Access Compliance Report

Public Rights-of-Way

(Curb Ramps)

Intersection ID: 13430	Main Street: 3RD_ST	Cross Street: JOHN_BELK_FY	Location: W
ADA ID: 084C2A4950C3	Ramp Type: BlendTrans1	Initial Pass/Fail: Fail	Overall Compliance: No
		Severity Score: 12.5

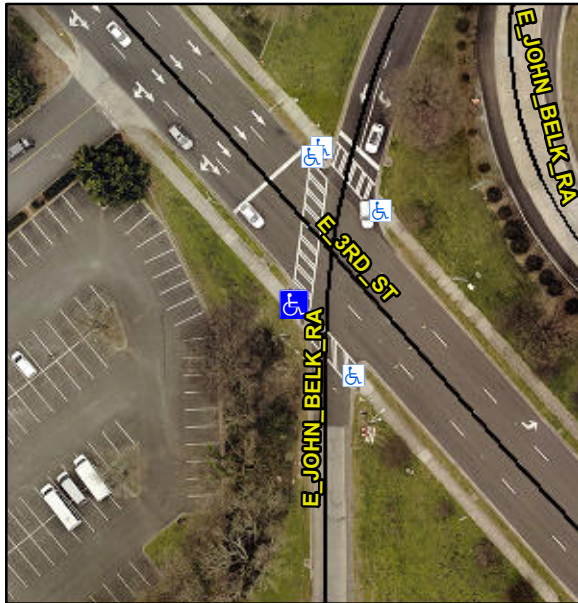
Not Found, R304.5.3

Compliance	Description	Data	Compliance	Description	Data
N/A	Ramp Length (in)	248.0	Yes	BlendTrans Slope (%)	3.6
Yes	Ramp Width (in)	92.0	No	BlendTrans XSlope (%)	5.6
N/A	Flare Type LT	N/A	N/A	Flare Type RT	N/A
N/A	Flare Slope LT (%)	N/A	N/A	Flare Slope RT (%)	N/A
N/A	Flare Traversable LT?	N/A	N/A	Flare Traversable RT?	N/A
N/A	Landing Length (in)	N/A	N/A	DWS Provided?	N/A
N/A	Landing Width (in)	N/A	N/A	DWS Contrast?	N/A
N/A	Landing Slope (%)	N/A	N/A	DWS Length (in)	N/A
N/A	Landing X Slope (%)	N/A	N/A	DWS Full Width?	N/A
N/A	Landing Curb? (Y/N)	N/A	N/A	DWS Offset (in)	N/A
N/A	Shared Landing?	N/A			
N/A	Gutter Ponding?	N/A	N/A	Gutter Slope (%)	N/A
N/A	Gutter Lip Ht (in)	N/A	N/A	Gutter X Slope (%)	N/A
N/A	Painted X Walk1?	Yes	N/A	Painted X Walk2?	Yes
	X Walk 1 Direction	To SE		X Walk 2 Direction	To NE
	X Walk 1 Width (in)	120.0		X Walk 2 Width (in)	120.0
	X Walk 1 Slope (%)	2.9		X Walk 2 Slope (%)	2.4
	X Walk 1 X Slope (%)	2.9		X Walk 2 X Slope (%)	3.9

Remove & Replace Curb Ramp With Two New Directional Ramps or Equivalent.
